COLORADO OPERATIONS

RE: Henderson Mine POC Well MNGW-1 Low pH Status Update - Fourth (4th) Adequacy Review, Climax Molybdenum, Henderson Mine, File no. M-1977-342

TECHNICAL MEMORANDUM

Re: 1070.19.02 Henderson Mine - No Name Gulch
Groundwater Segregation Mitigation Options

Figure 2

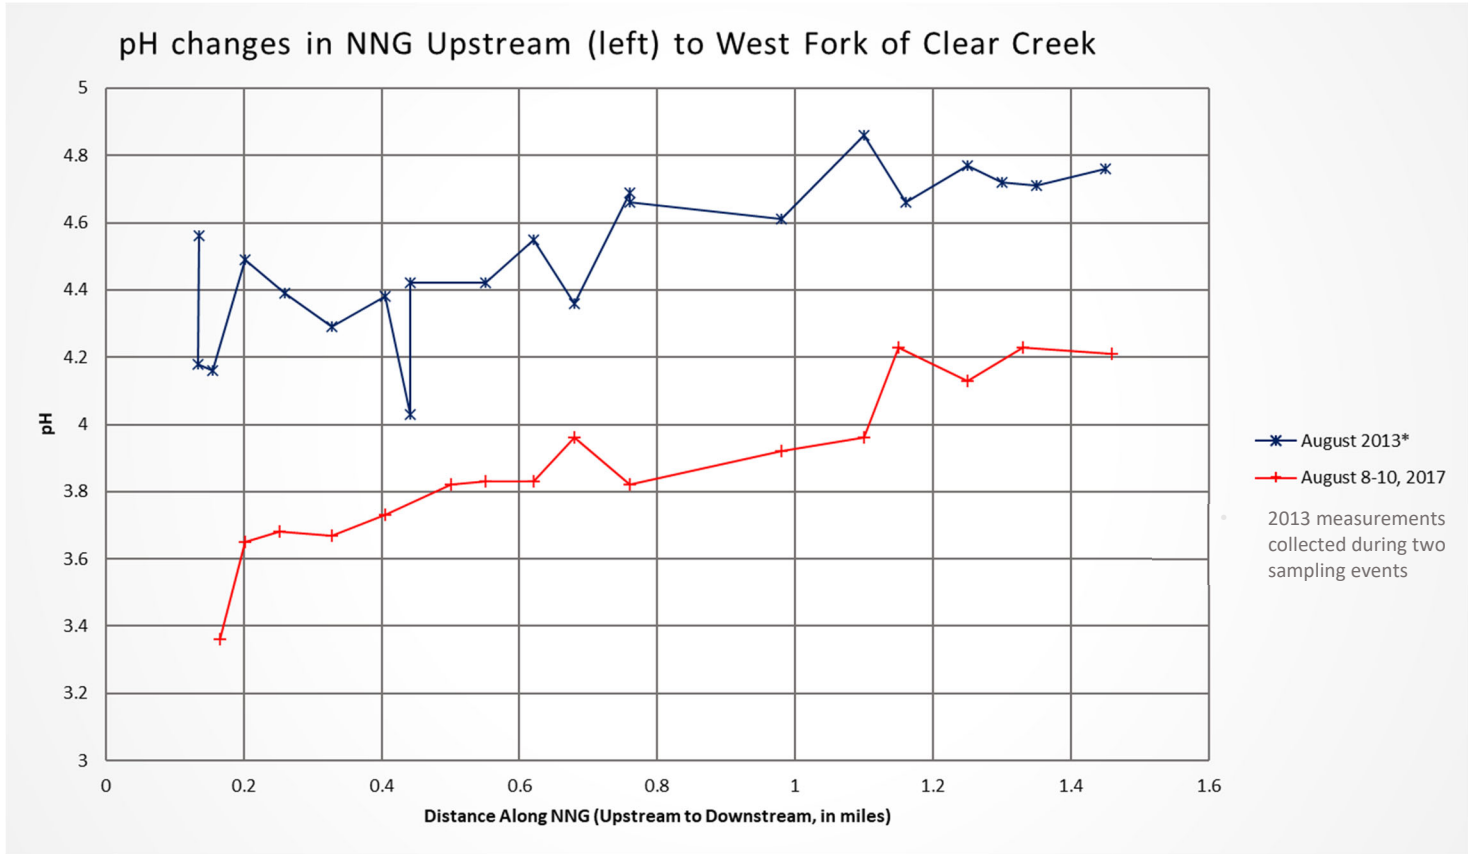
In the July 2022 memo, Henderson mentioned that the presence of manganocrete and/or ferricrete deposits were observed during past transect evaluations of No Name Gulch. During the August 2022 sampling event, Henderson confirmed the presence of ferricrete (figure 2) indicating the long-term existence of acid-rock drainage (ARD) conditions in No Name Gulch. Similar ferricrete deposits have been used as exploration guides and indicators of the geochemical baseline conditions prior to mining operations.

Figure 3

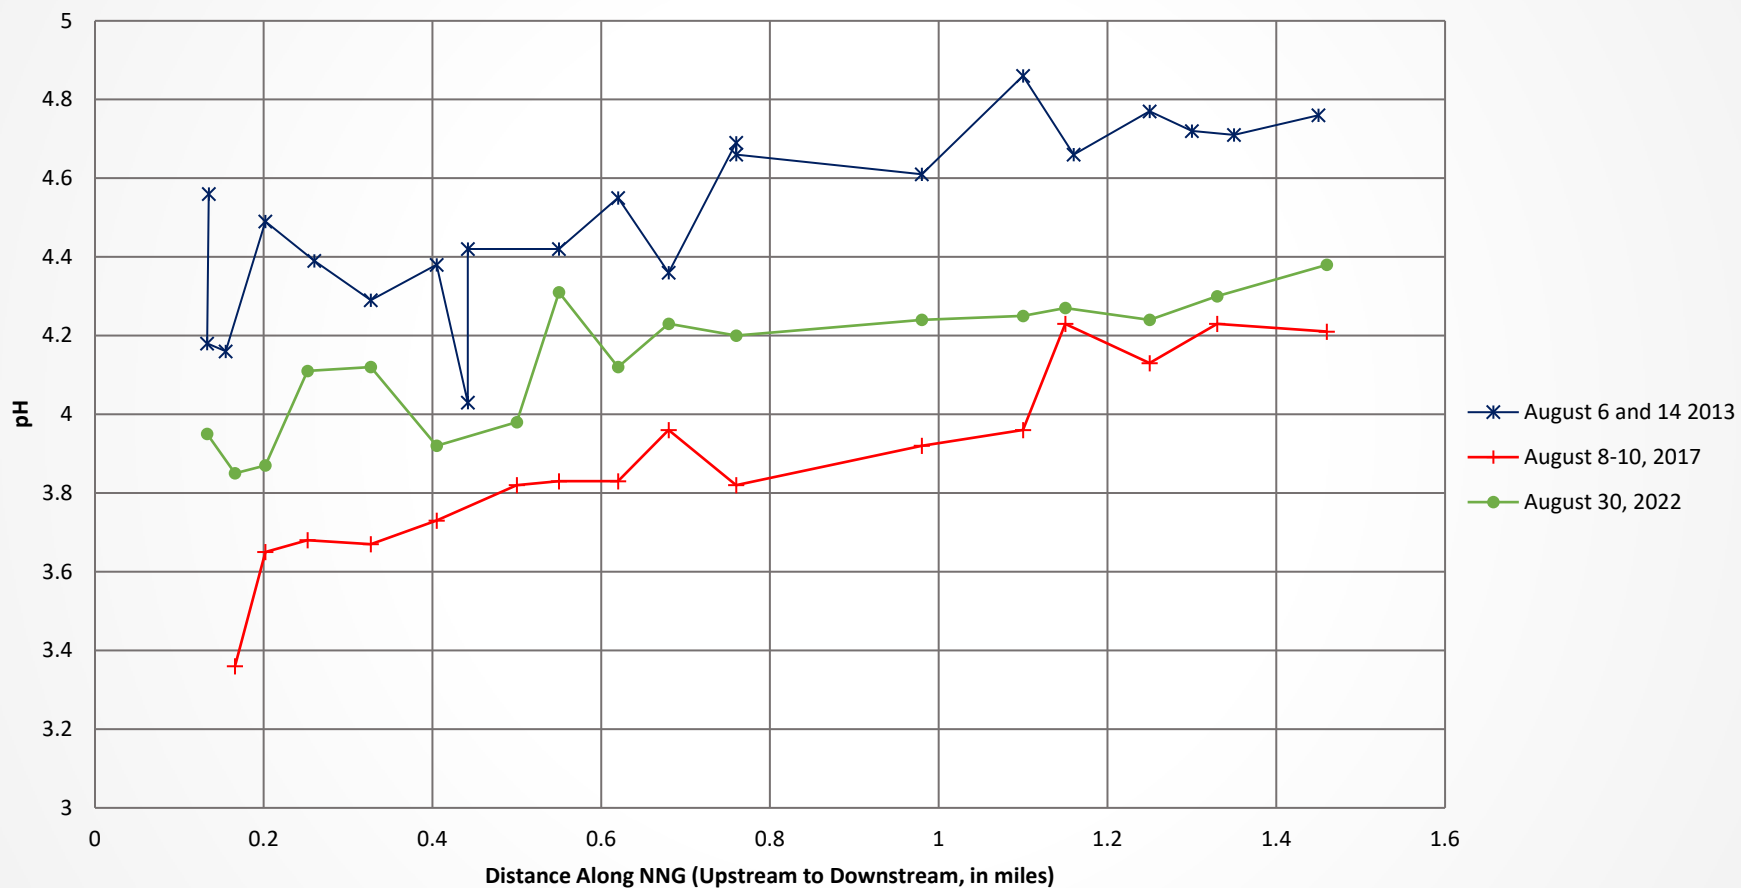
The pH results from the August 2022 evaluation fell between the 2013 and 2017 results (figure 3). To test hydrologic factors, Henderson calculated a theoretical volume of water required to increase the pH by the 1.0 s.u. observed between the 2013 and 2017 datasets. In all of the sampling transect analyses, a gradual increase in pH was recorded from the top of the drainage to the lowest sampling station. To further evaluate temporal and spatial changes in pH along No Name Gulch, Henderson evaluated various mixing scenarios. The objective of the analysis was to see if changes in pH in No Name Gulch can be explained by mixing of naturally occurring No Name Gulch water with a more neutral water source. Understanding the factors influencing pH changes in No Name Gulch is needed to evaluate mitigation alternatives. Henderson's initial analysis consisted of mixing calculations using a pH of 3.9 for No Name Gulch and a pH of 7.4 for a neutral water source (value based on pH measurements recorded in nearby Butler Gulch). The mixing analysis found that based on hydrogen ion concentrations alone, it would take a mix ratio of nine (9) parts of a higher pH water source to one (1) part No Name Gulch to achieve an increase to the pH of the mix water by 1.0 s.u.
